Letter of Class I Permissive Change

Subject: Class I Permissive Change for FCC ID: VOB-P2180, IC:7361A-P2180

We Audix Technology Corp., hereby declare that FCC ID: VOB-P2180, IC:7361A-P2180 is applied class I permissive change, The differences between this application and original's ID as clarify in following pages.

Incremental schematics and layout change history from P2180_A01 to P2180_A04 is below.

P2180 A04

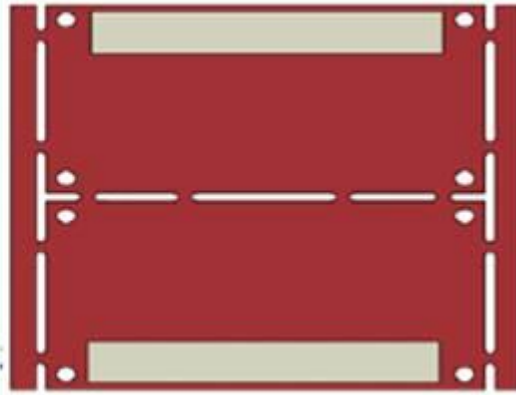
The A04 is exactly the same electrical BOM and PCB design as the A03, it is just the panelization that changes as shown below
